Product Change Notice (PCN)

PCN Number: PCN-0451148R-01

Product(s) Affected: PJ-037A

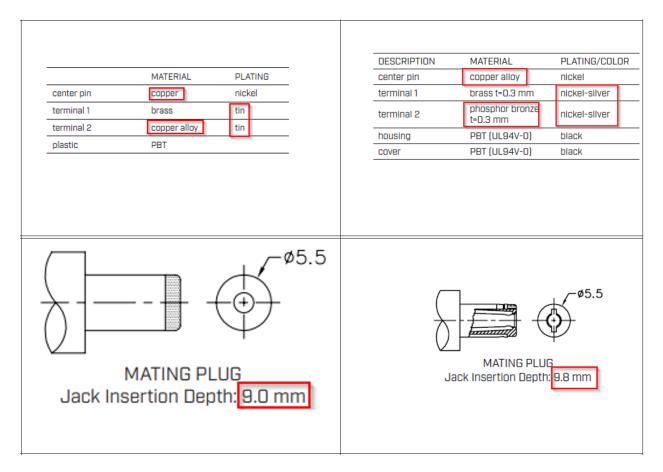
Description of Change: mechanical differences as shown below:

Insertion/extraction force adjusted to 0.3 ~ 2.0 kg
